## SERVICE INFORMATION

**ST-012-06**

**SUBJECT:** Defrost Control 031-01975-000 (S1-03101975000) SAP#10211

**UNITS:** BAUP-\*042, BAUZ-\*042

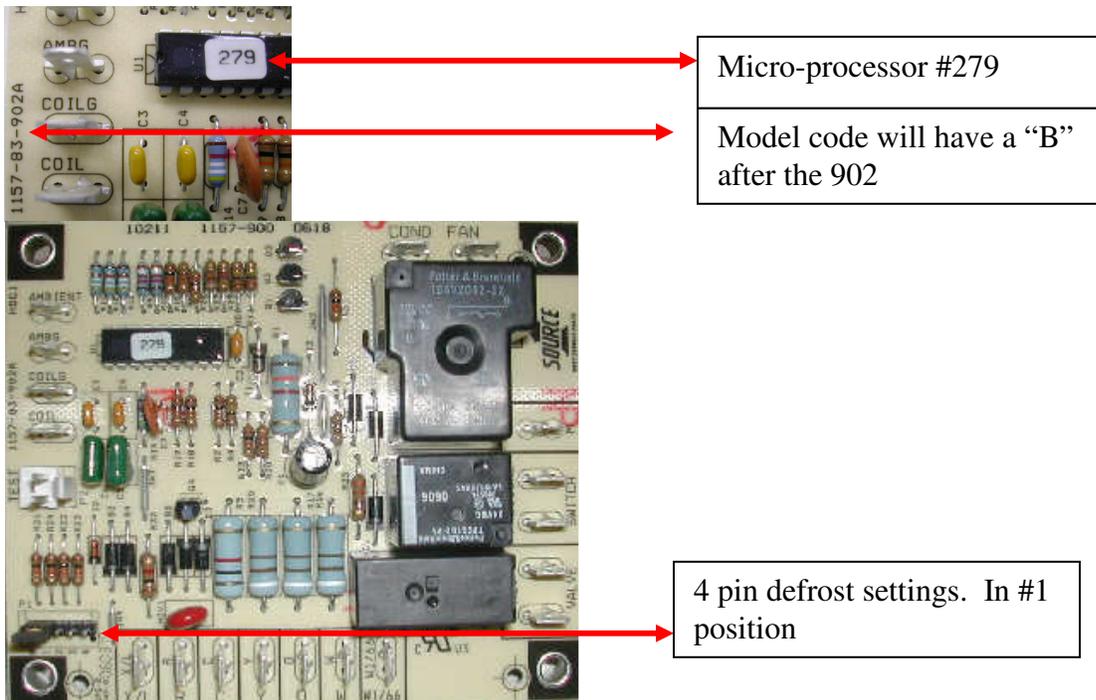
The 031-01975-000 defrost module used on these units has (4) pin settings, of which only (3) were programmed and used. Engineering had the maker of the module program the 4<sup>th</sup> pin to duplicate the parameters of the test module that worked. This pin #4 would be designated a service pin for those applications that needed a longer defrost cycle. These new boards were introduced into the line the 2<sup>nd</sup> week April, 2006. Source One will stock the revised boards as the standard replacement.

The New version of the S1-03101975000 board with the revised service Pin #4 is designated as a "B" version. Unfortunately the vendor failed to change the code to a "B" on the first shipment of new boards. However, the micro-processor was changed and will have a #279 label.

Before changing the pin setting, make sure the unit charge is correct, air flow is correct, and the liquid line sensor is good and making contact with the line. If these are ok, change the pin position to #4 and run through a cycle. There is a small COP loss for keeping the units in defrost for longer periods of time.
